Block 21 Design Response

05.06.2022

In the planning process Block 21 was reviewed by the City's design consultant, Cannon Design Group. The findings and recommendations of the design consultant were provided to the project team in a letter dated November 10, 2021.

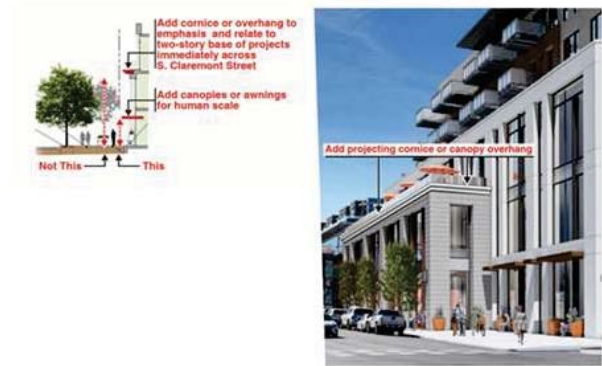
1. Replace the office building large glass facades with a solid wall with deep window recesses, as shown on the other three building facades.

2. Add a projecting cornice or roof canopy at the second level to emphasize the two-story massing along street frontages to better relate to the adjacent new projects and the pedestrian scale of the sidewalks. At the planning commission's discretion, the third floor could also be setback to reduce its impact on the overall building massing and the human scale of adjacent pedestrians.

Response: The design includes elements and materials to articulate the mixed-use nature of the project with office and residential. This project encompasses an entire city block at 6-stories and will be looking to attract a single tenant for approximately 180,000 S.F. The glass façade at the corner identifies the office entry and needs to be scaled appropriately for the overall building. We have refined the design to include a stronger horizontal expression at the floor in the glass. The deep expressed mullions break down the massing of the glass while still maintaining the identity.

Response: We have made significant massing adjustments to the proportion of the cornice at the second level to create a better scale for the building.

SEATING AND LANDSCAPE
AT MAIN ENTRY PLAZA

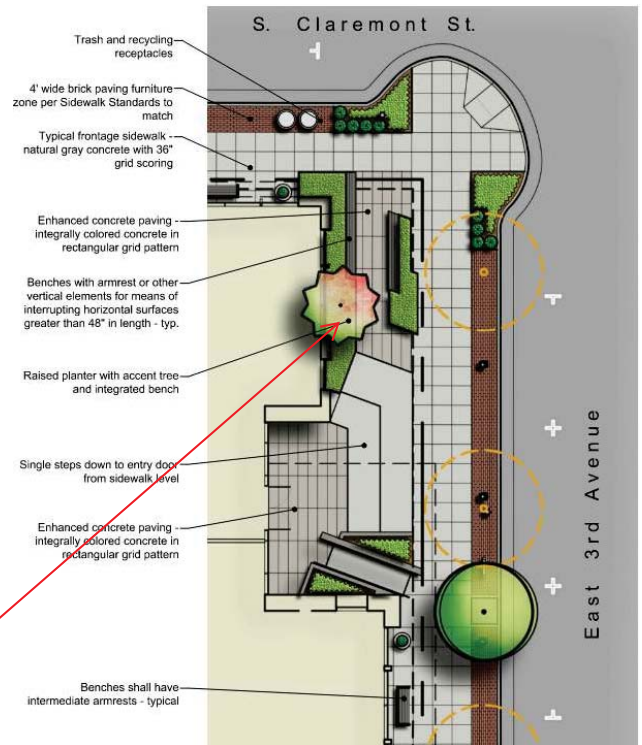
3. Clarify the intent for use and landscaping for the plaza adjacent to the office entry.

4. Provide street front awnings or canopies to better relate to the adjacent pedestrian areas.

5. Extend the darker wall facade with recessed window up to the sixth floor consistently around all facades.

Response: The intent is a well landscaped passive space to provide seating and highlight the building entry.

ADDED PEDESTRIAN SCALE
CANOPY AT CENTER BAYS
ALONG FIRST LEVEL

Response: The project has been refined to to create a better pedestrian experience. Pedestrian scale canopies were added at the center bays along the first level.

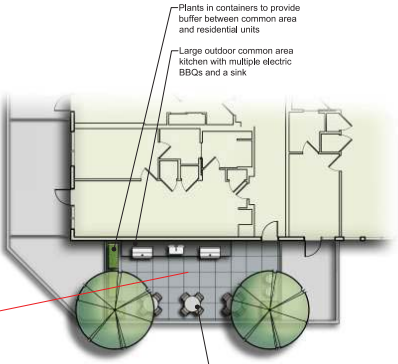
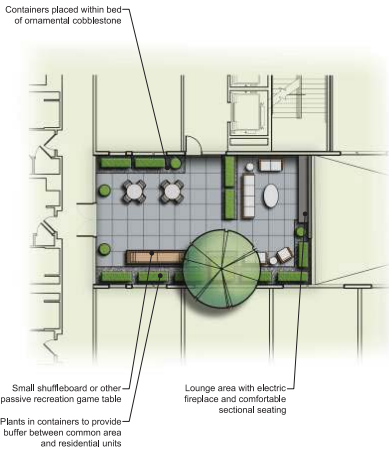
10. Resolve the privacy and landscaping of the spaces adjacent to the open atrium on the fourth floor.

Response: The privacy and screening is accomplished with a combination of a fireplace wall and landscape planters.

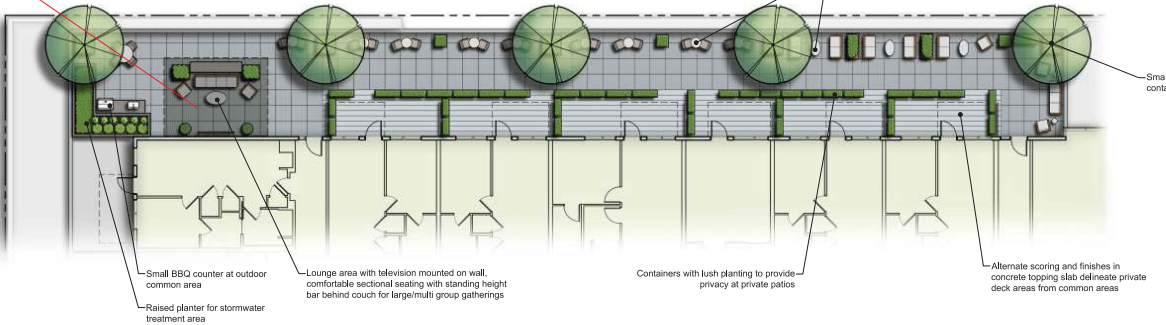
11. Reevaluate the mix of residential common open space and private open spaces. One option would be to move this common open space to the roof, where the code allows, which is becoming quite common on larger residential projects.

Response: The private and shared open space has been further developed with key areas with enhanced amenities located for shared use. The private open space along the building is utilized as a buffer between the shared open space and the residential units.

ADDITIONAL LANDSCAPING AND AMENITIES FOR ACTIVE PEDESTRIAN FRIENDLY CORNER PLAZA

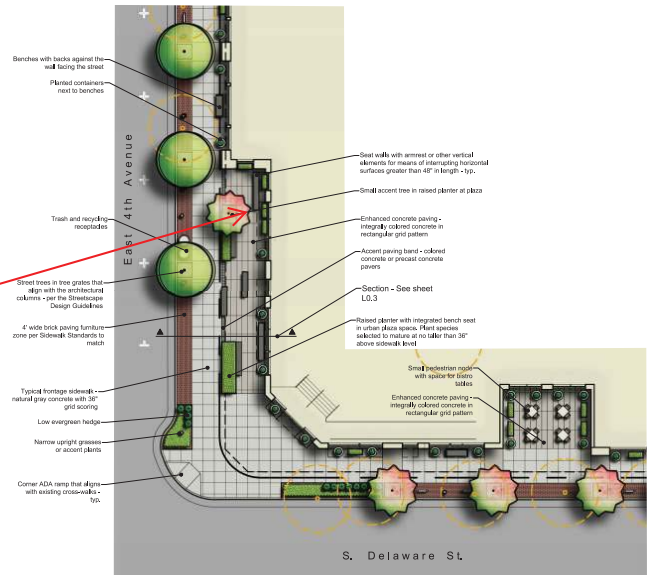
12. Consider adding more landscaping at the small plaza at the corner of East Fourth Avenue and South Delaware Street.

Response: The planters have been enlarged to provide additional planting. The design allows for the landscape areas in the planters while also providing the pedestrian circulation and seating for an active streetscape.
